Proposal Outline planning application for the construction of up to 140,000 sqm of employment floorspace (use class B8) with ancillary offices and facilities and servicing and infrastructure including new site accesses. Internal roads and footpaths, landscaping including earthworks to create development platforms and bunds, drainage features and other associated works including demolition of the existing farmhouse.

Location Land east of Junction J.11, M40, Banbury

Application No. 23/03428/OUT

Following submission of the Flood Risk Assessment and Drainage Strategy (FRA & DS) produced by Delta-Simons (dated May 2022 Project No: 21-2141.01), the LLFA response was included with Oxfordshire County Council composite response dated 12th of February 2024, the LLFA objected to the development. The detailed comments from the LLFA are reproduced and Mabbett's responses on behalf of the applicant are below.

Drawing
**Conceptual Drainage Sketch
Catchment A**

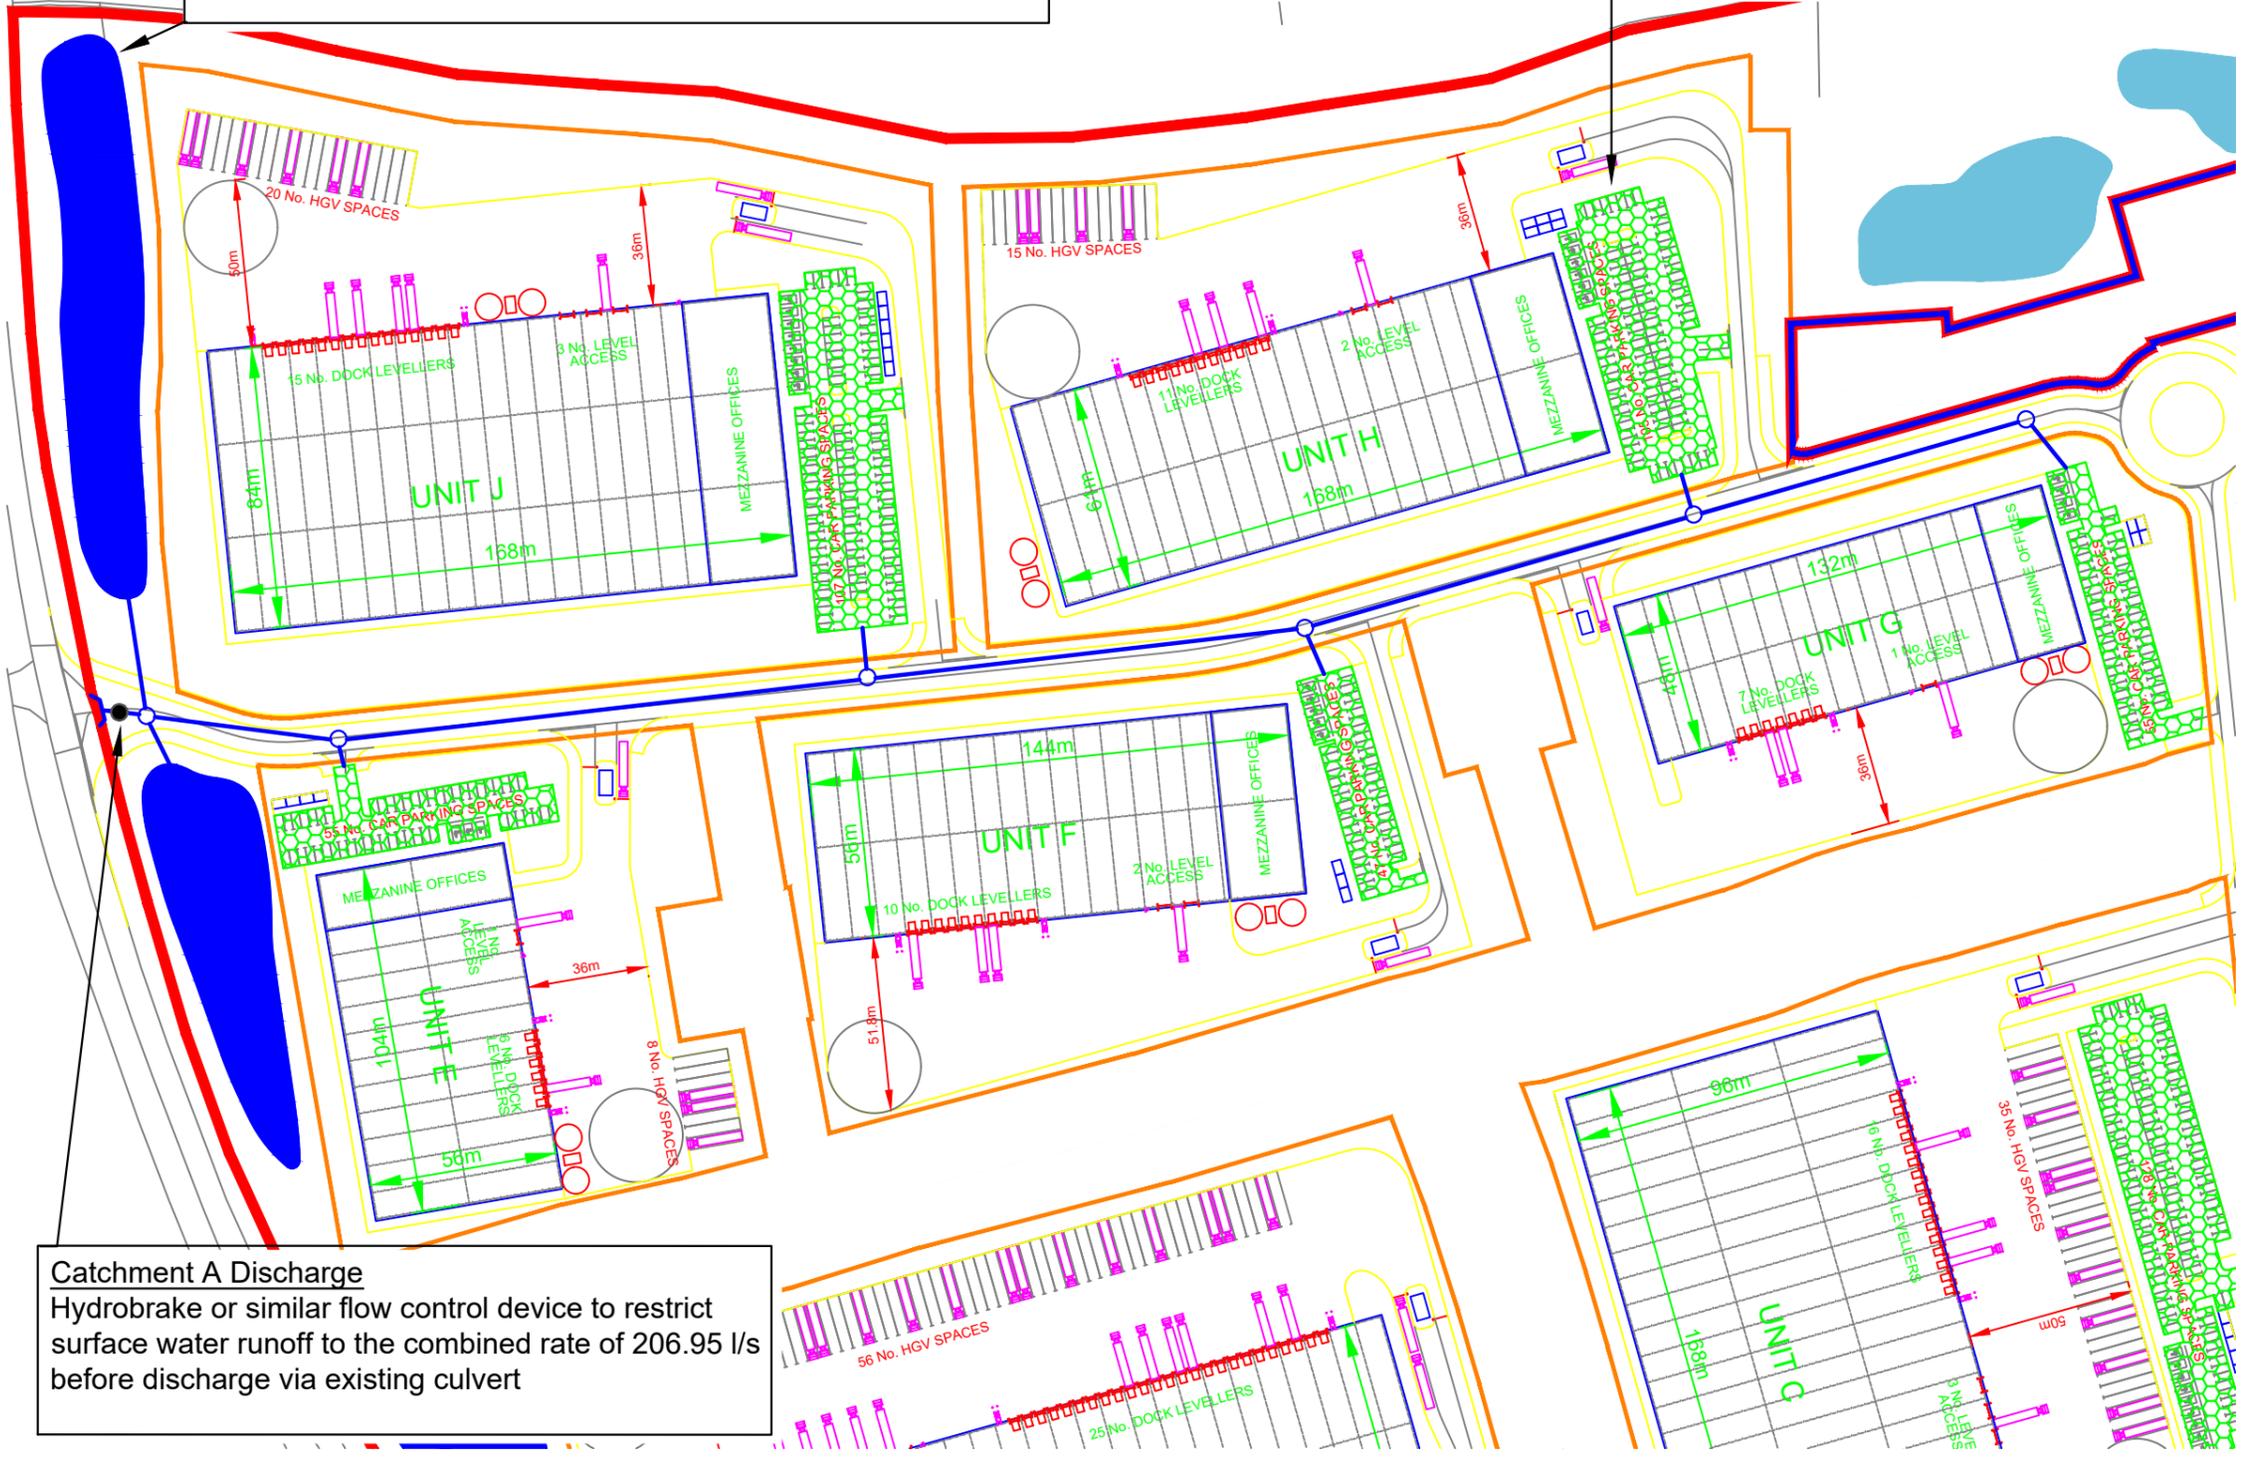
"The FRA explains the surface water drainage strategy however a surface water drainage drawing is required to demonstrate the surface water strategy. Proposed SuDS features and drainage infrastructure needs to be shown indicatively. Outfall locations to be shown, storage details of proposed SuDS features and infiltration rates if applicable".

A Surface Water Drainage Drawing is included in Appendix A of this letter.

As described in the Delta-Simons FRA & DS, surface water runoff will be discharged to the neighbouring site's drainage system and ultimately the River Cherwell via two culverts along the western Site boundary at a combined maximum rate of 460.51 l/s.

Surface water runoff up to the 1 in 100 year plus 40% climate change allowance event will be attenuated on site. A total attenuation volume of 21,526 m³ will be required to achieve the discharge rate and will be provided in the form of ponds, swales or detention basins located in the west of the Site and also within permeable paving.

The Drainage Drawings shows that the require amount of attenuation is available within the car parking areas and the proposed ponds within the north-western extent and within the demise of the southern plots.

Catchment A Attenuation Ponds
Attenuation Ponds with a combined surface area of 6,569.79m².
Ponds will be 1.5m deep with banks at a gradient of 1 in 3.
Ponds will provide 9,854.68m³ of attenuation

Catchment A Permeable Surfacing
Permeable Surfacing with a surface area of 9,184.7m², with a
sub-grade depth of 0.4m and a void ratio of 30%, totaling in
1,102.16m³ of attenuation

Catchment A Discharge
Hydrobrake or similar flow control device to restrict
surface water runoff to the combined rate of 206.95 l/s
before discharge via existing culvert

Drawing
**Conceptual Drainage Sketch
Catchment B Area**

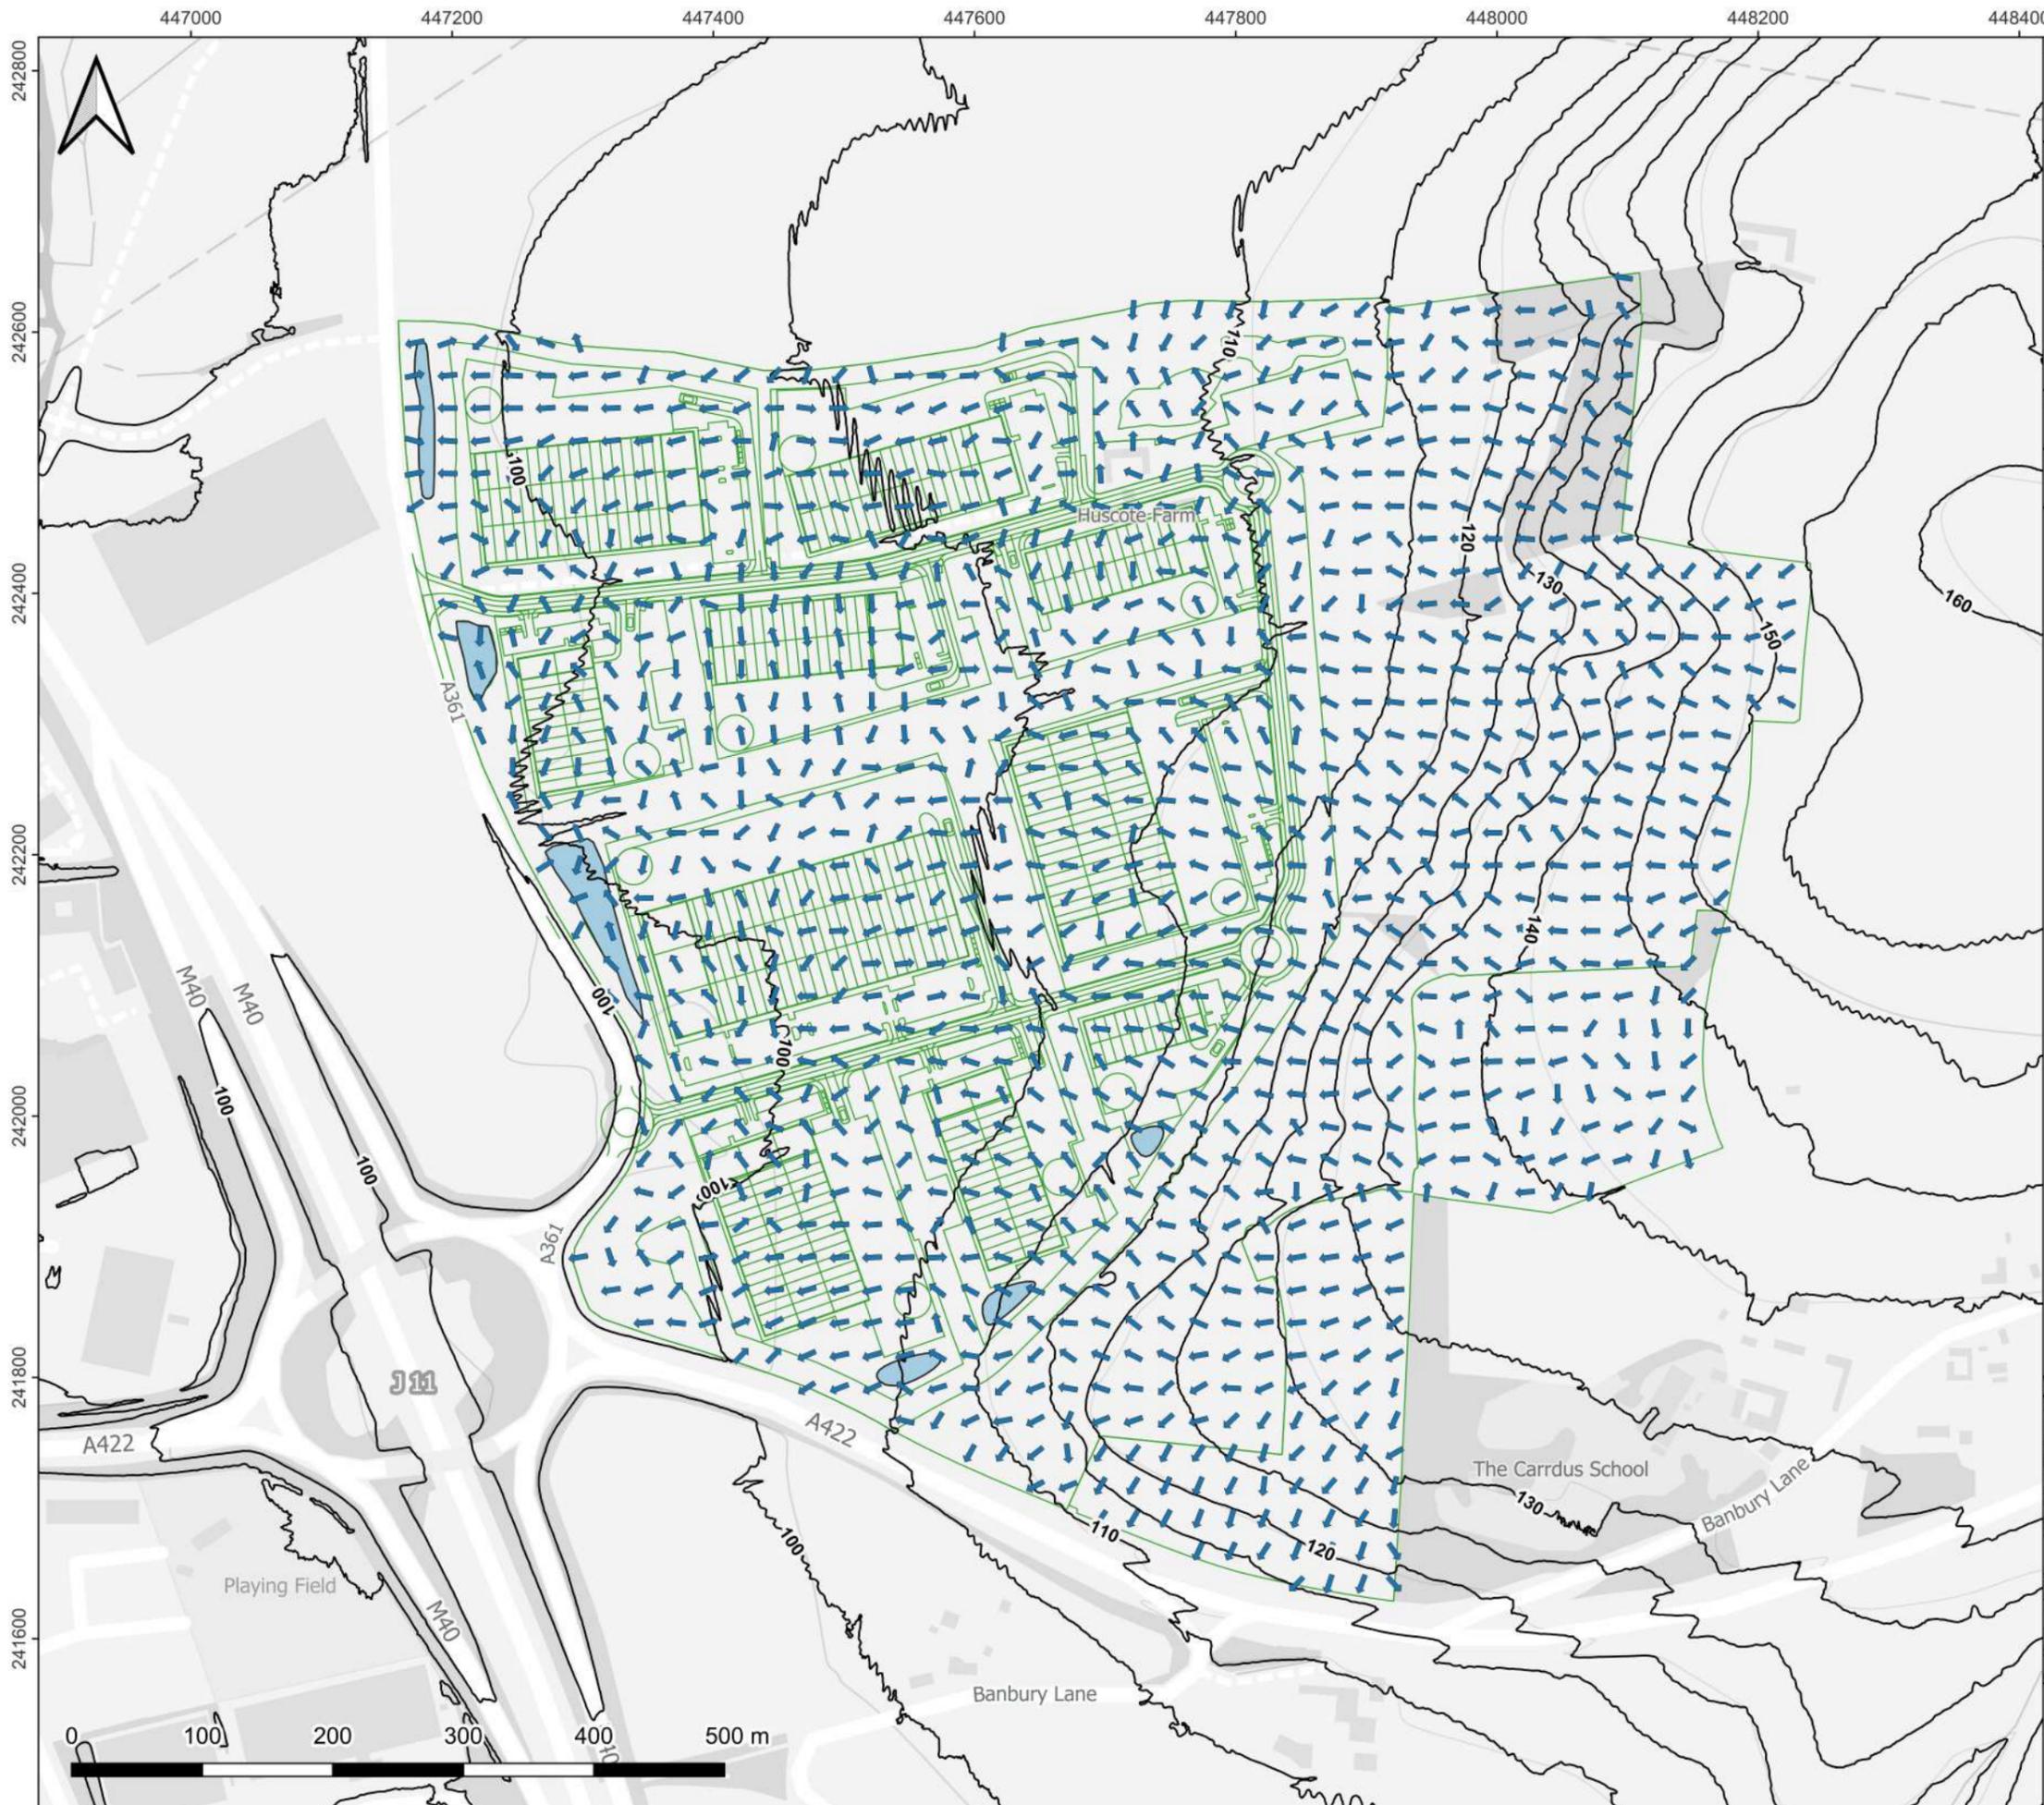
“The catchment areas have been broken down in the FRA, however a Catchment plan is required to highlight the extent of the areas. Stating the total impermeable area and the impermeable area including urban creep”.

A Catchment Plan is included in Appendix B of this letter.

The site can be split into two catchments each served by the two existing culverts at the lowest extents of the site. The site can be further split into individual plot catchments at the detailed design stage if required. It is reiterated that the layout is not fixed, and the catchment areas may change as a result of works undertaken at the detailed stage.

Area (m ²)	Discharge Rate (l/s)
Catchment A	143,060	206.9
Catchment B	175,287	253.56

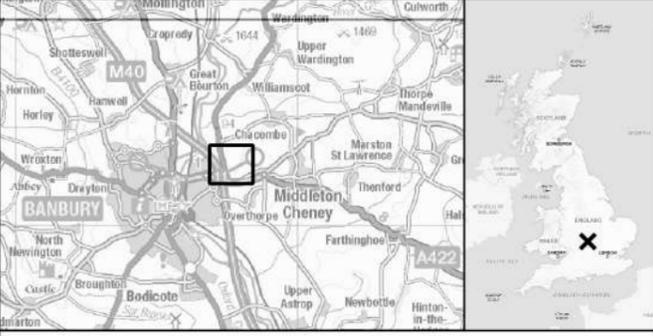
Surface water exceedance flow plans required to demonstrate how the site is draining to ensure all surface water is being picked up by the proposed drainage infrastructure.

Surface Water Exceedance Flow Plan is included as Appendix C of this letter.

The proposed drainage system is proposed to attenuate the full balance of surface water generated by the site during a 1 in 100 year plus 40 % CC storm at the 1 in 2 year existing greenfield runoff rate (estimated using ReFH2 method). The likelihood of exceedance is therefore, beyond the design event and unlikely to occur. Especially when considering the required freeboard inherent in attenuation pond design.

We have therefore utilised the existing topography of the site to show the potential flow paths throughout the site. The plan shows that in the event of exceedance, surface water will generally flow westward and away from the site.
